SUBJECT: Addendum No. 1
City of Lookout Mountain, GA
Chickamauga Trail Pump Station Improvements

ADDENDUM NO. 1

CHICKAMAUGA TRAIL PUMP STATION IMPROVEMENTS

CITY OF LOOKOUT MOUNTAIN, GEORGIA
GEFA LOAN NUMBER: GF2024017
CTI PROJECT NO. G24017-01

JOB NO.
G24017-01
ISSUE DATE
04/01/2025
DRAWING NO.
E-001.1

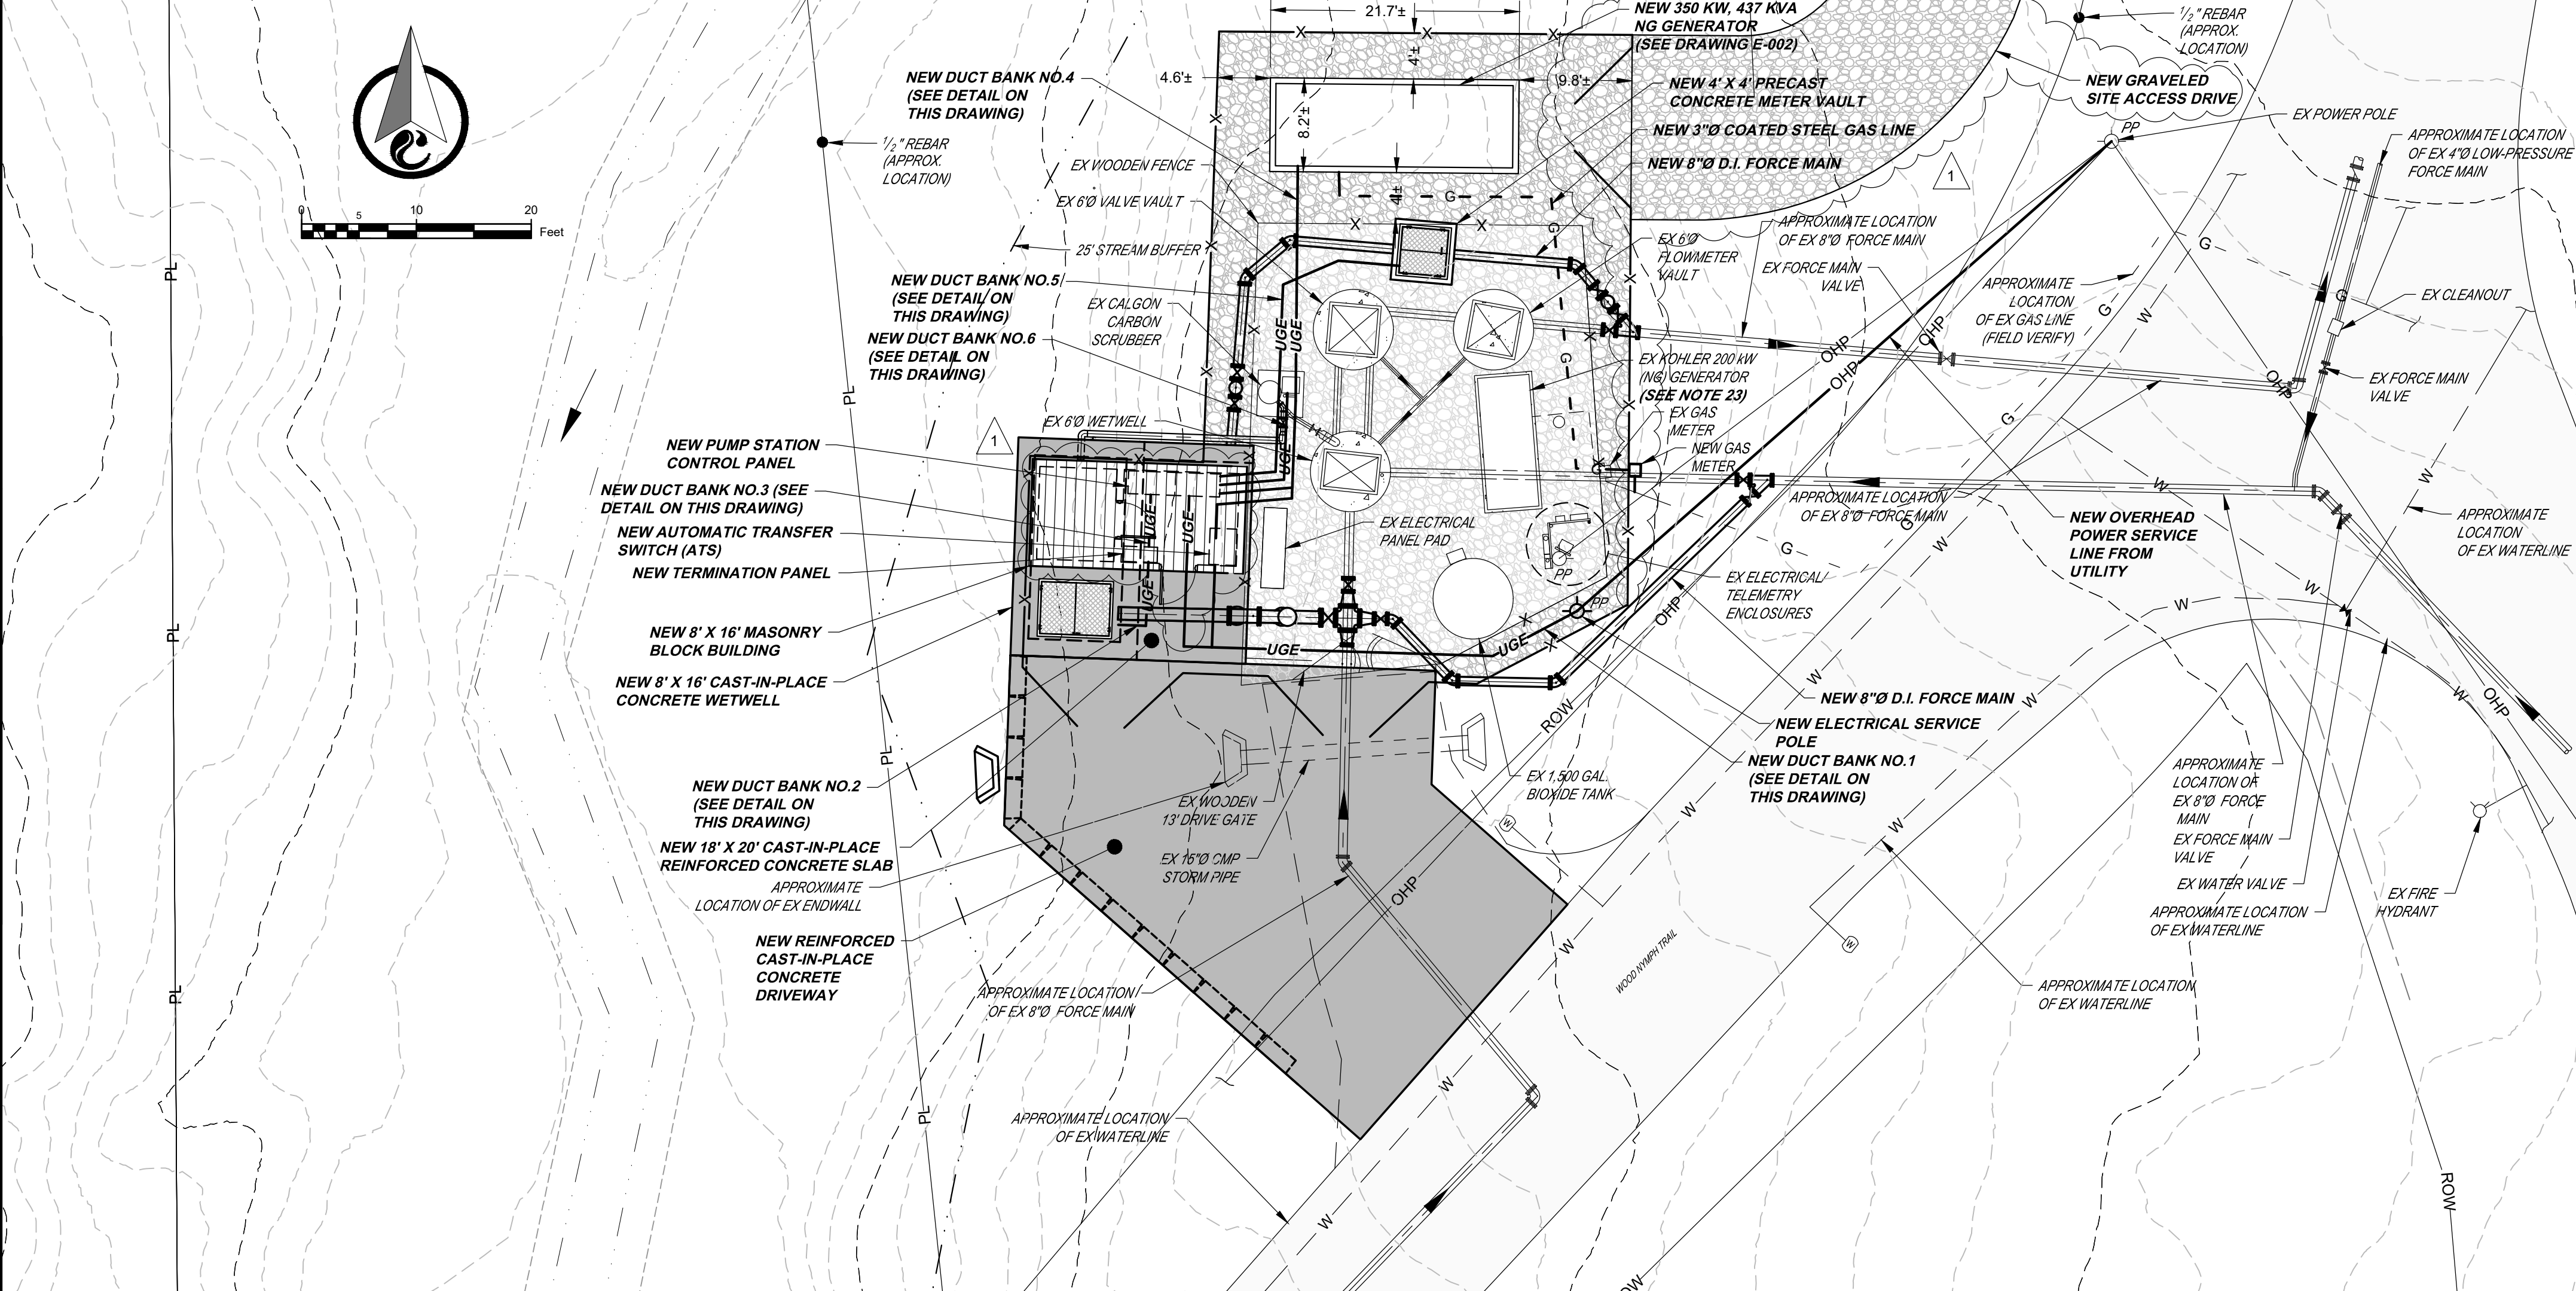
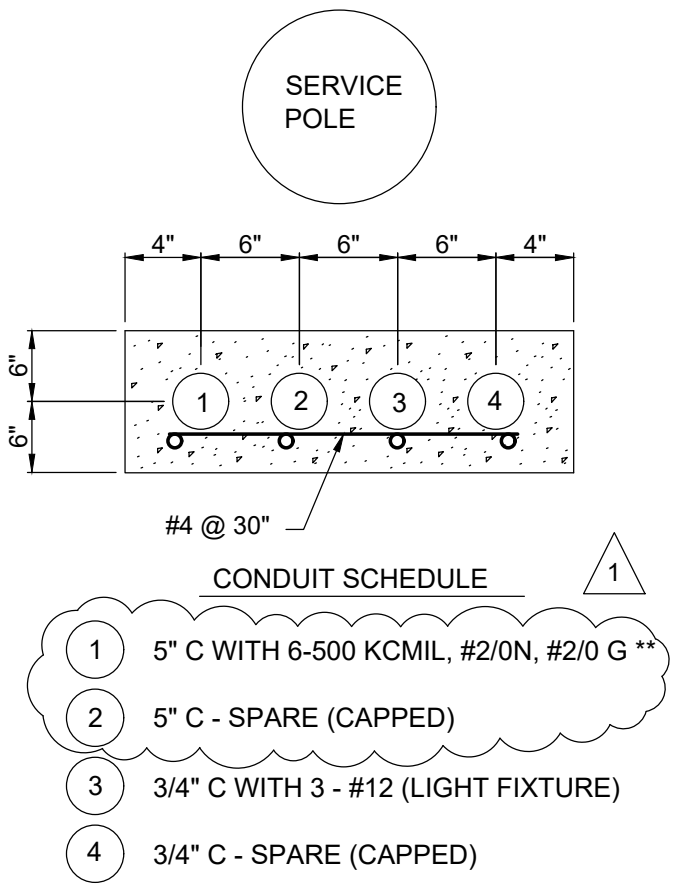
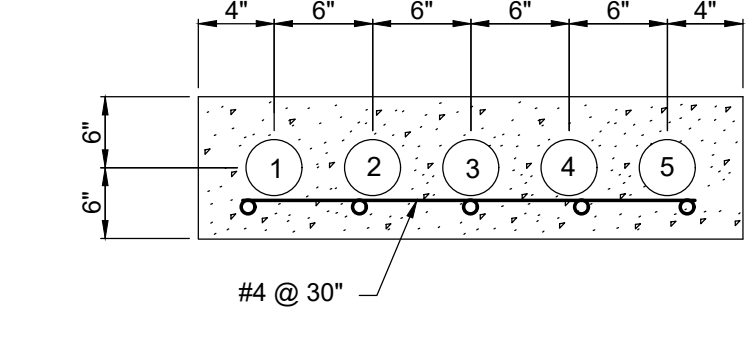
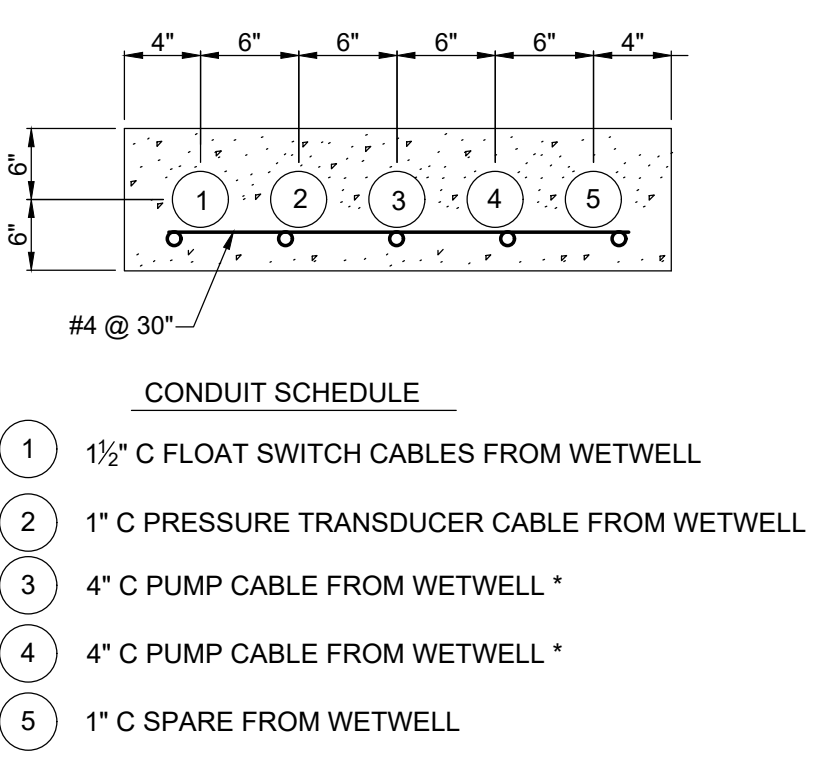
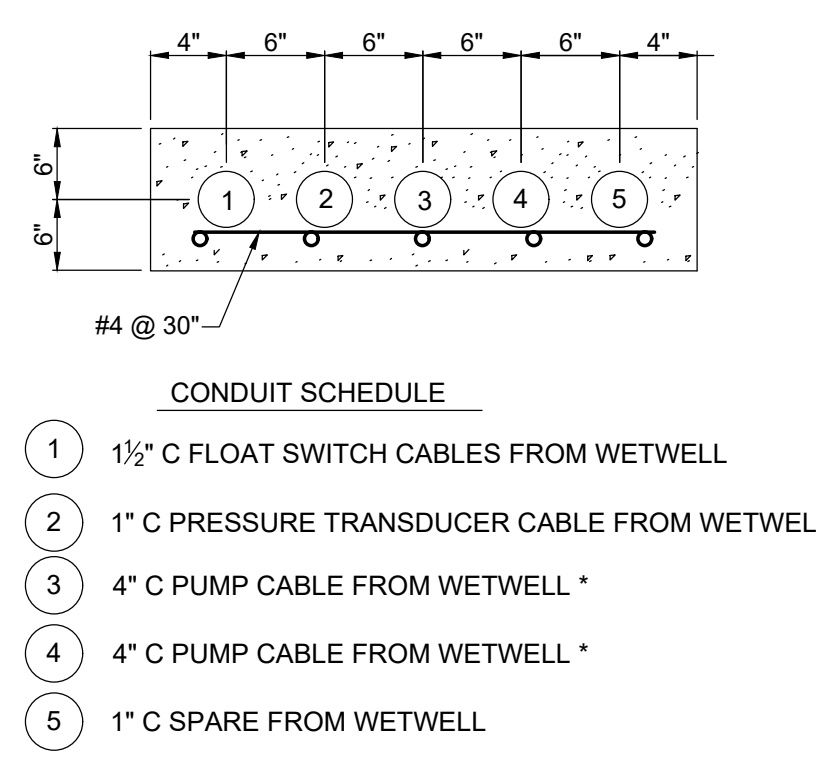
2. Was the electrical service shown on Drawing E-001 a misprint? It shows 6 – 500 kcmil in a 4" conduit. By code, that is not legal.

NO.	DESIGN	REVISIONS			DATE	BY	APPD
		DESCRIPTIONS	DATE	BY			
1	GMC	LENGTHENED MASONRY BUILDING, CHANGED CONDUIT SIZE IN DUCT BANK NO.1, REVISED NOTE 23.	08/25	GMC			
	DRAWN						
	CHECKED						
	APPROVED

Response: The conduit size was changed to 5" on Drawing E-001.1 (included in this Addendum).
